Alders Road Culvert Layout

Alders Ave Culvert Replacement

Alders Road Culvert Anchorage System

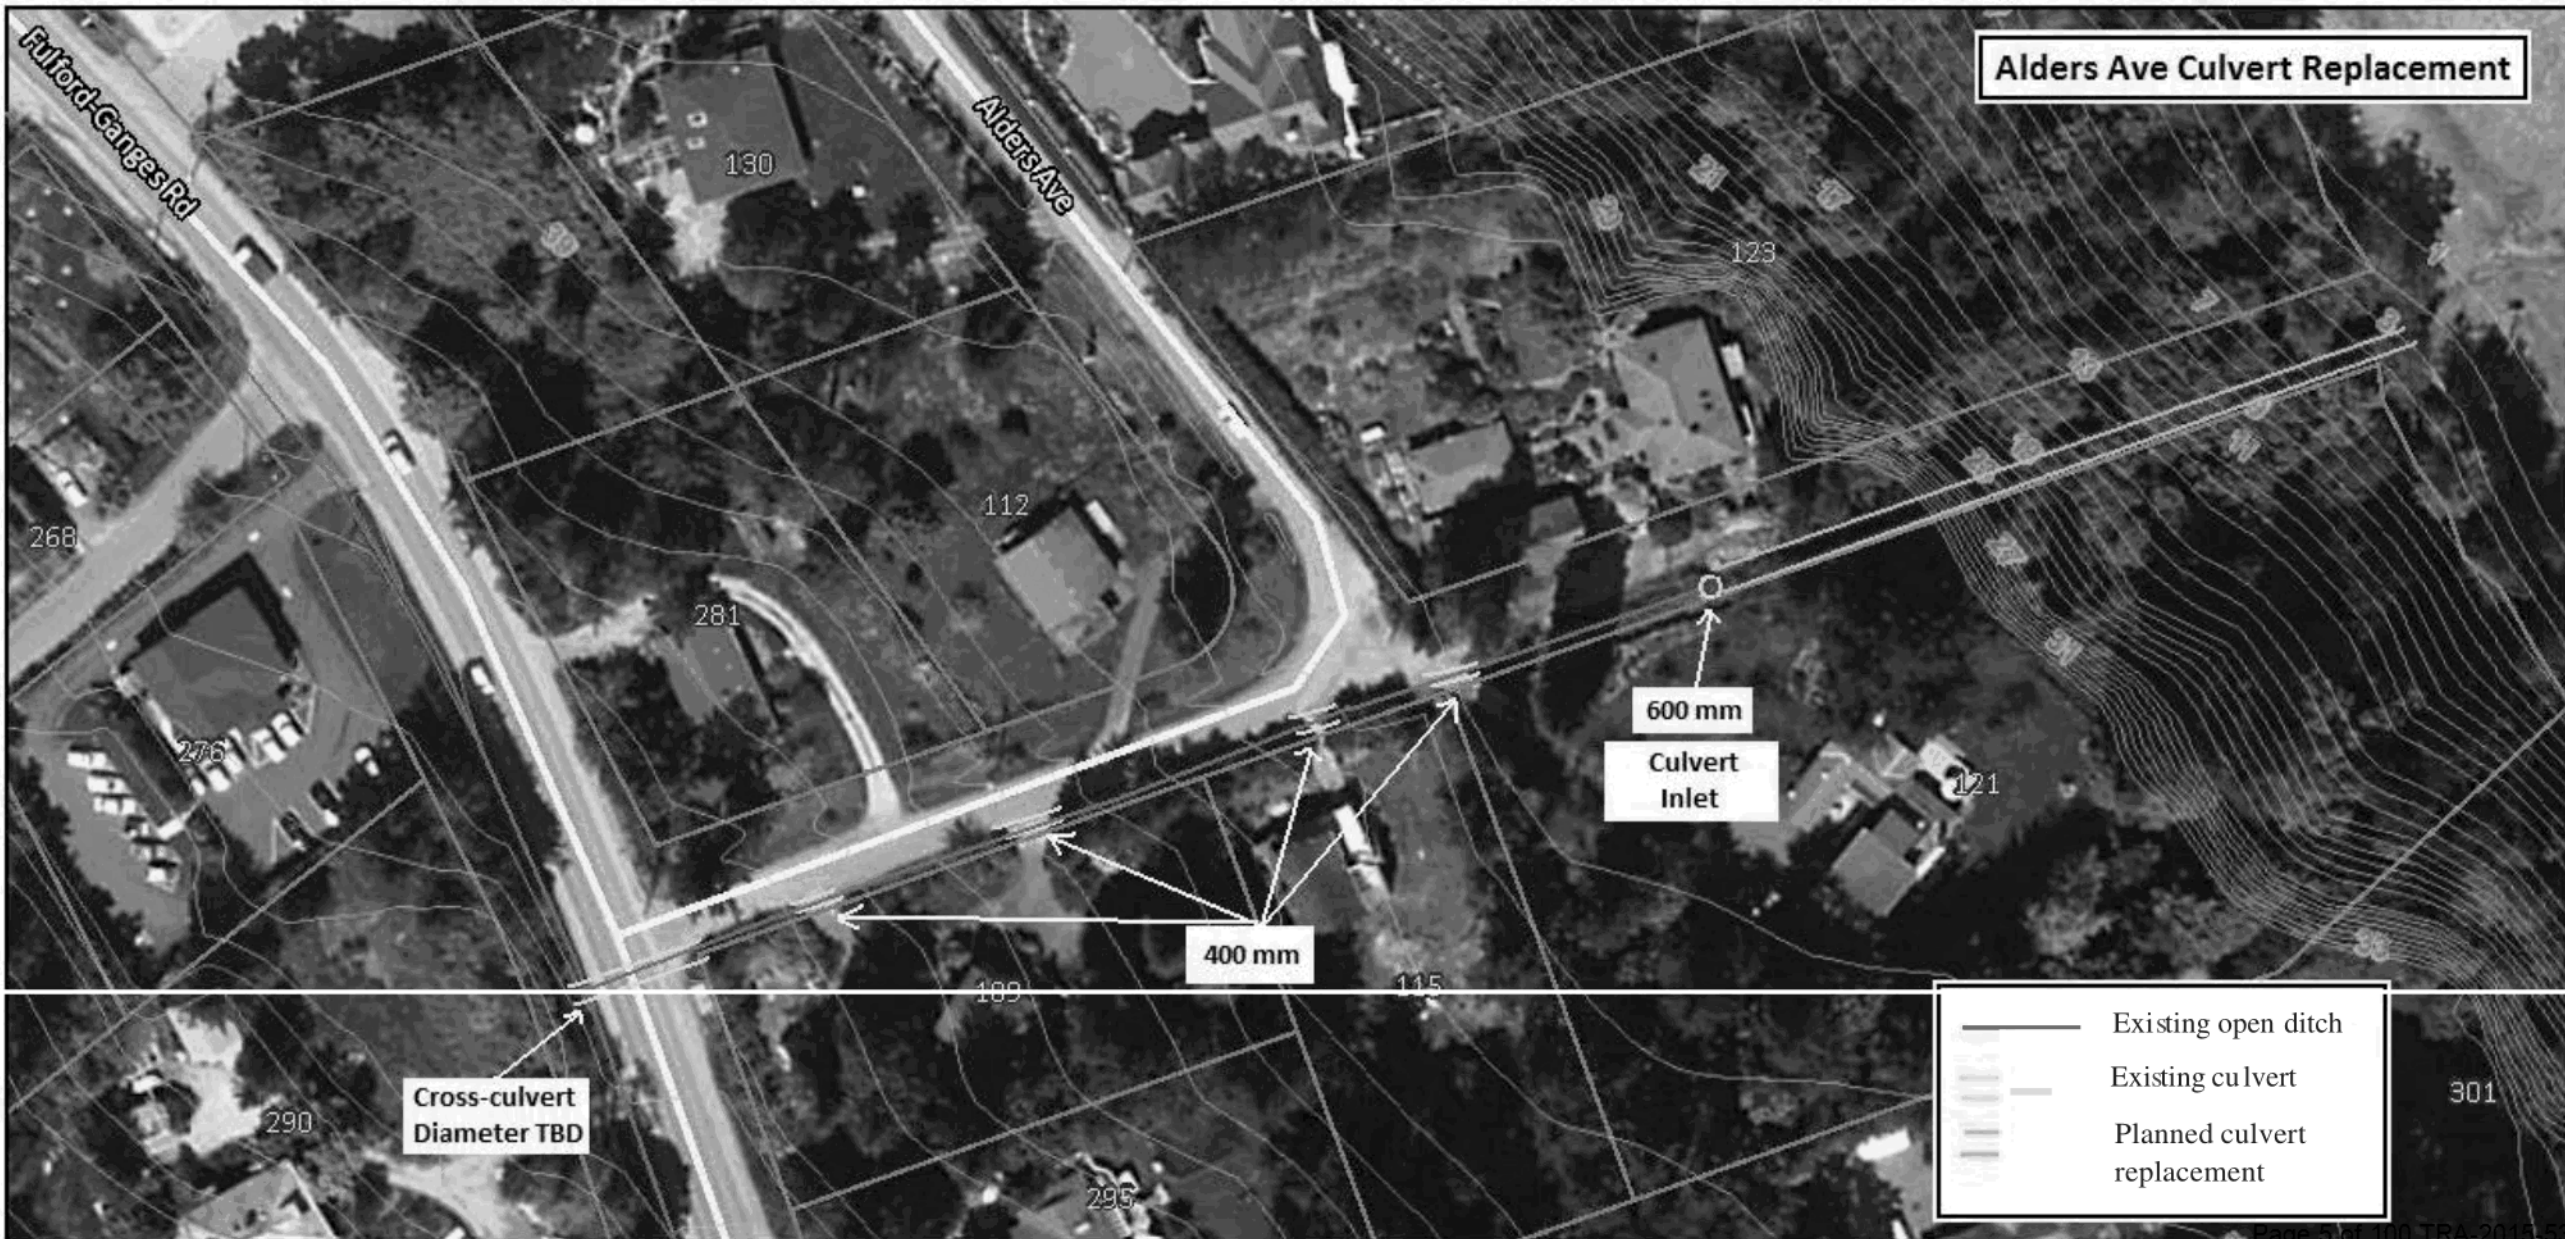
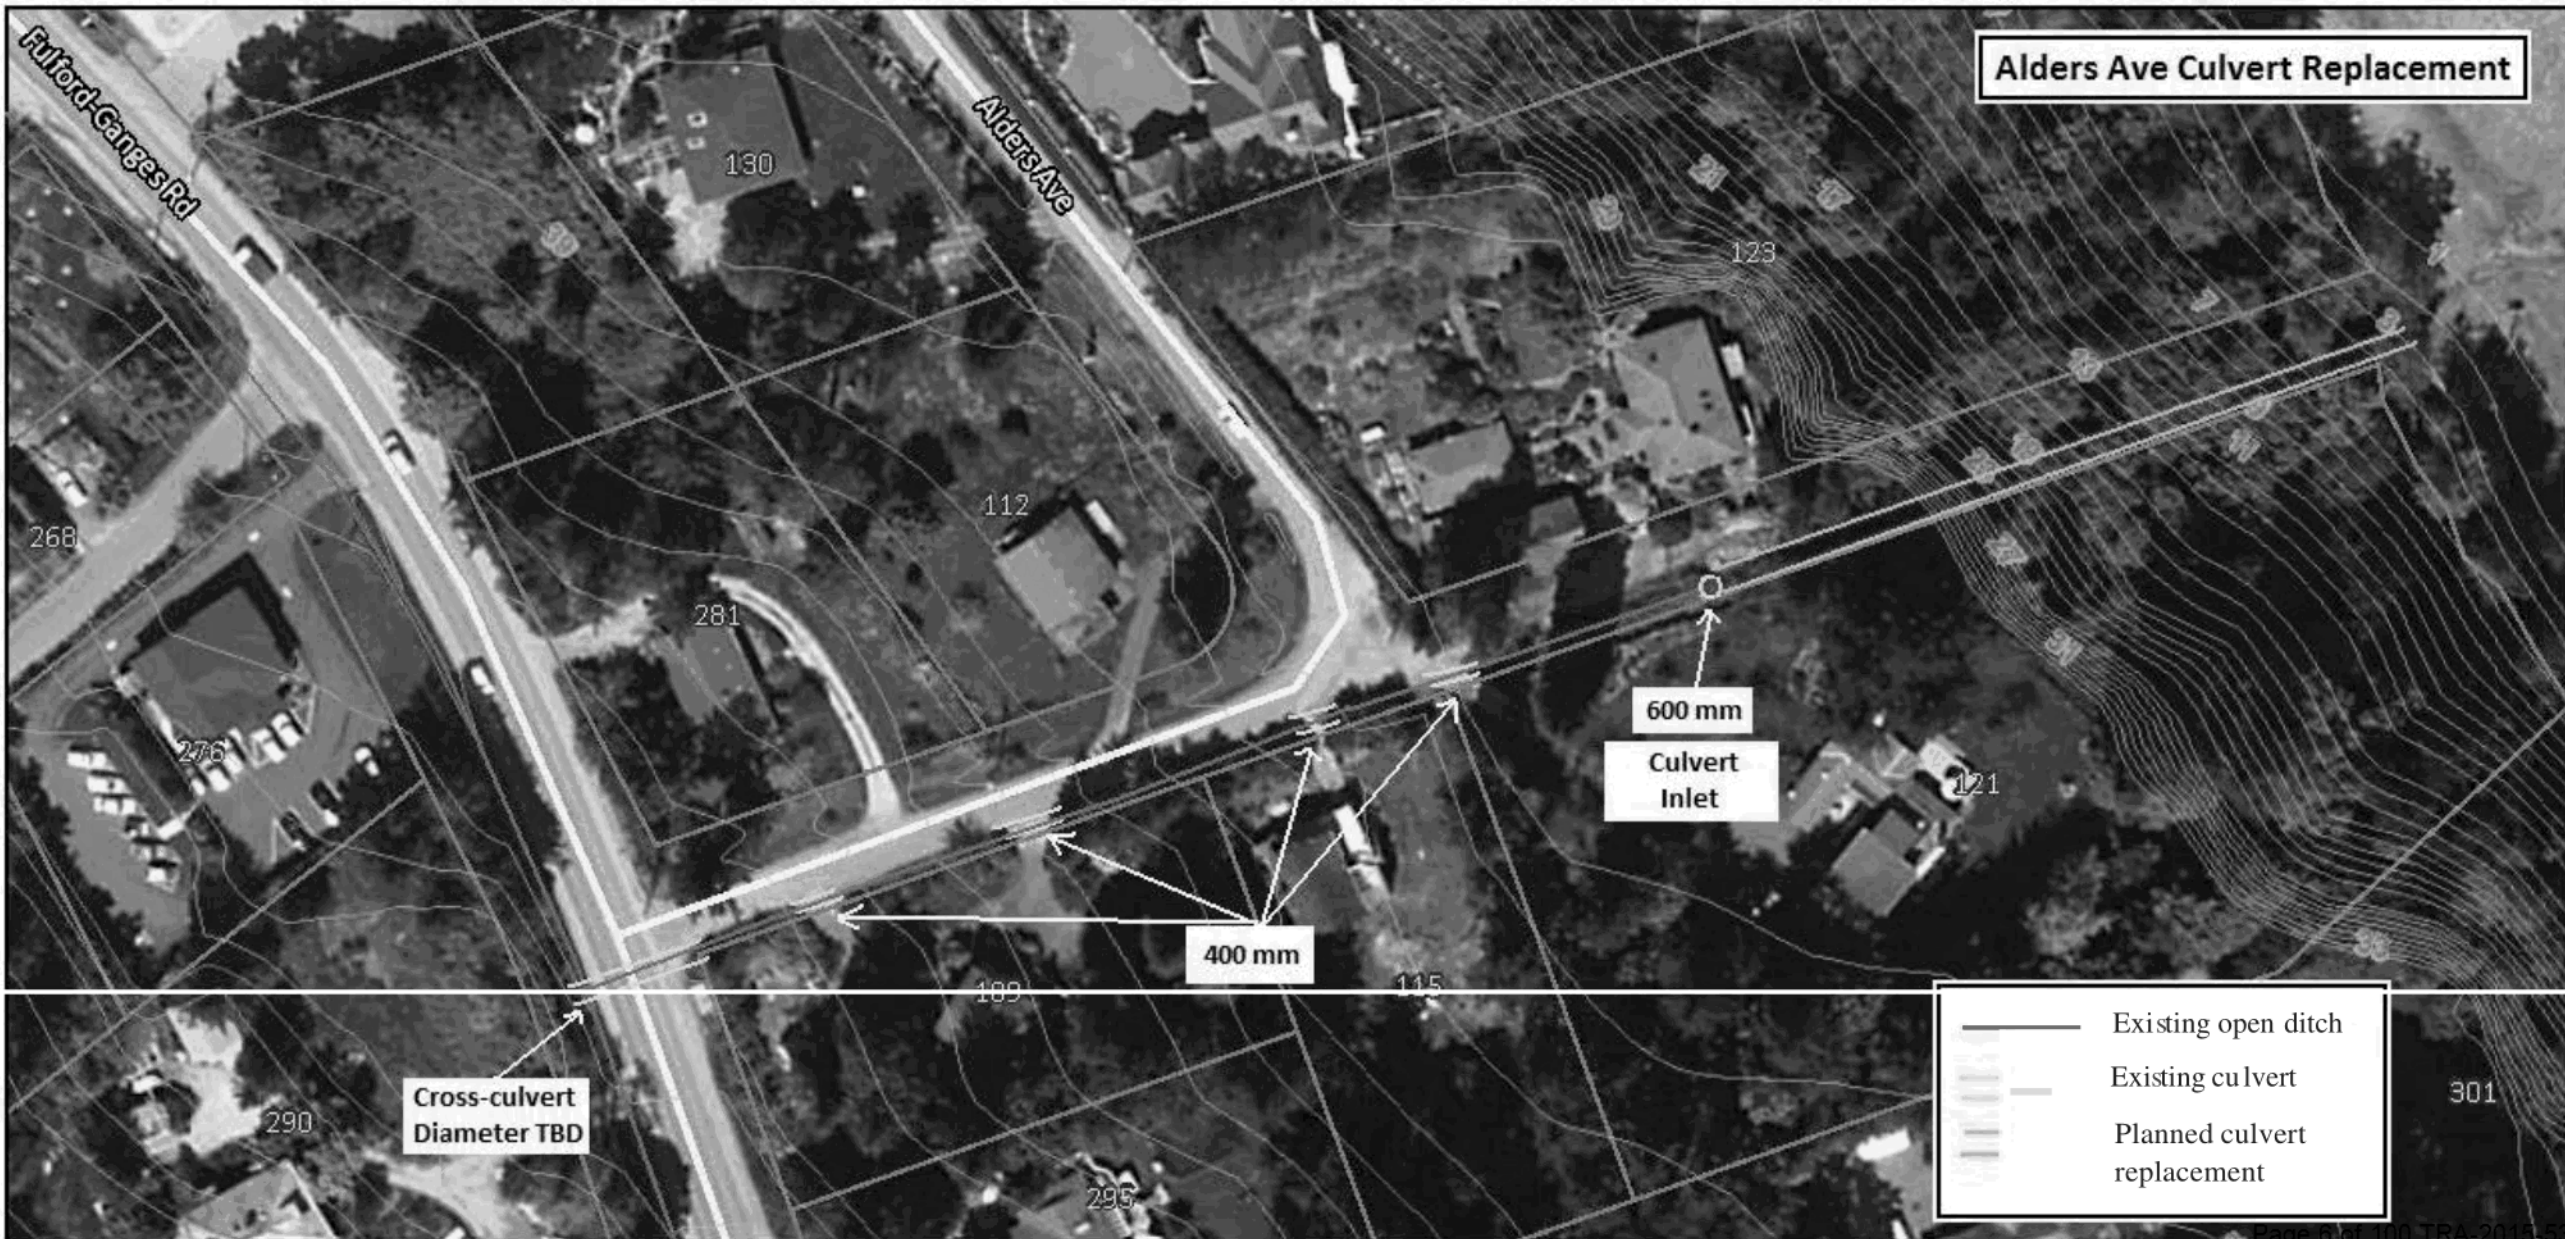
The layout is a rough draft based on my field measurements.

The Cost Estimate will be between \$17,521 based on this layout, see attached breakdown I will give you a better breakdown on cost as we finalize any changes from your Geotech people.

Alders Road Culvert Anchorage System

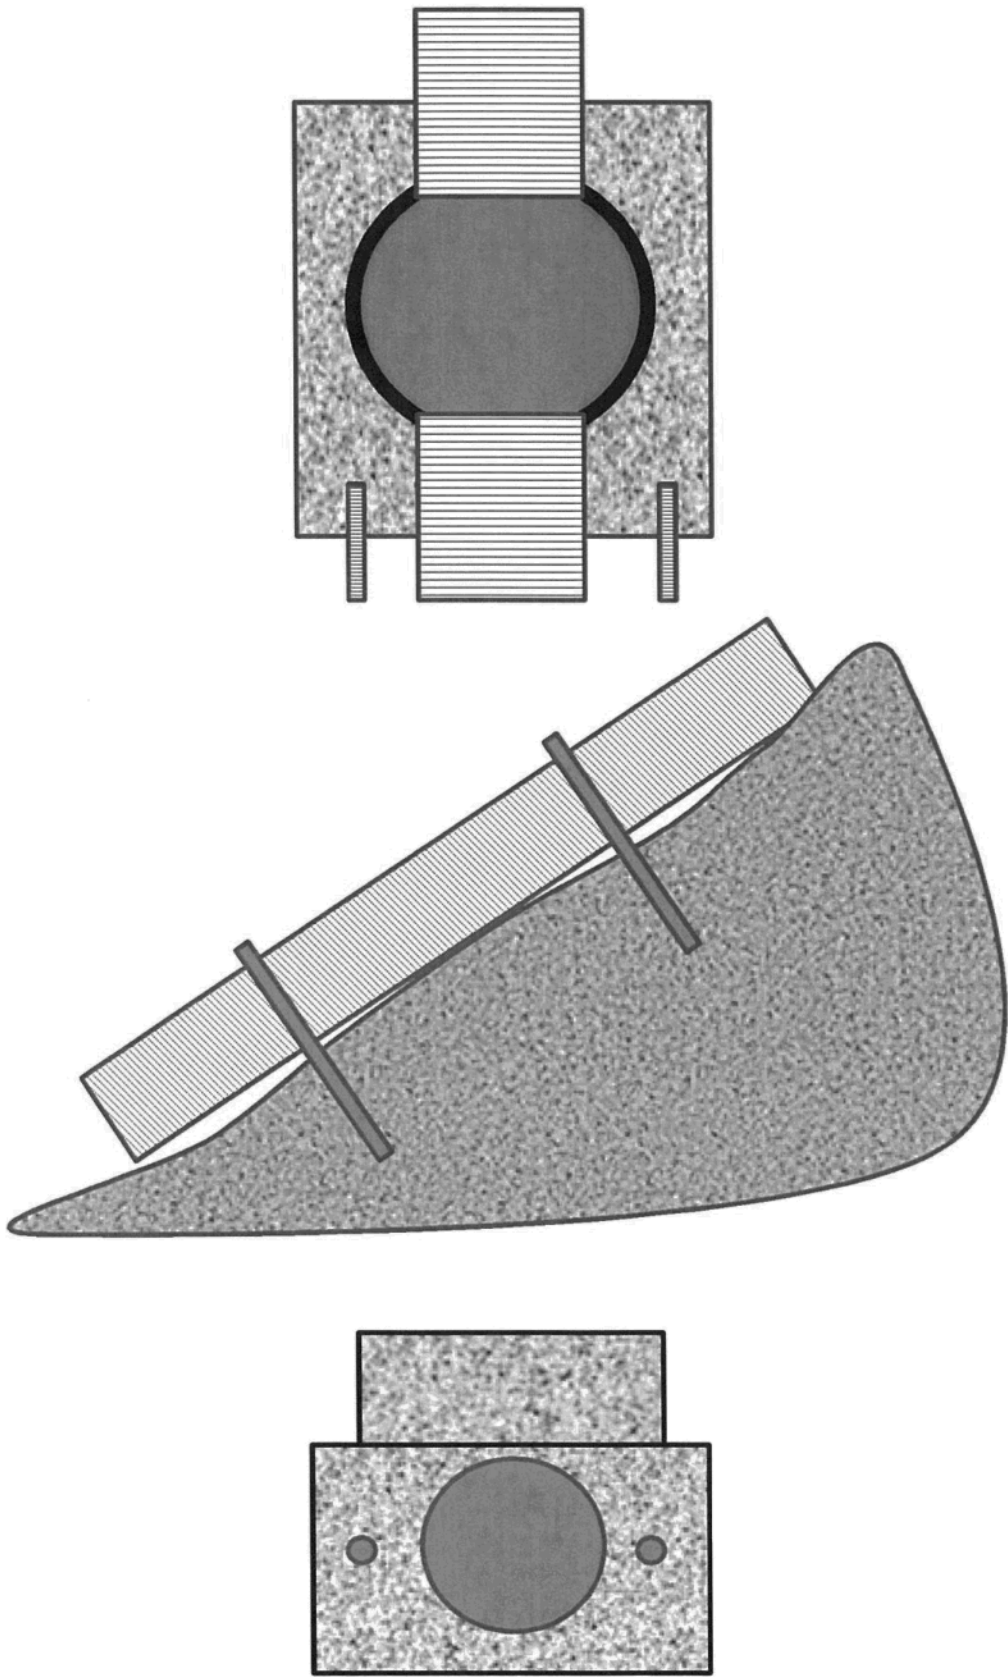
Thanks for the details. The top catch basin anchorage looks good. I'm confused as to the 2nd detail on the sheet. I'm assuming it's the concrete anchor going at the base of the hill? Or perhaps it's the catch basin anchor. Regardless if the pipe is 750mm diameter how can the block be only 600mm high? I have calculated a force that the pipe will be subject too at the base from the water crashing down, I want to make sure this concrete block is going to be sized adequately. Can you confirm your proposed concrete block size at the base? With 1.2m high by 1.2m wide I am looking at the anchor being 2.5m long.

Hi Sarah,
Thank you for your feedback.
I have adjusted the drawing to reflect your comments.
I will order the anchors and make sure the concrete is formed to your recommended sizes.
The first attachment is for the anchorage pad at the bottom of the slope and the second attachment is for the Catch Basin at the Top of the slope.
Regards,
David
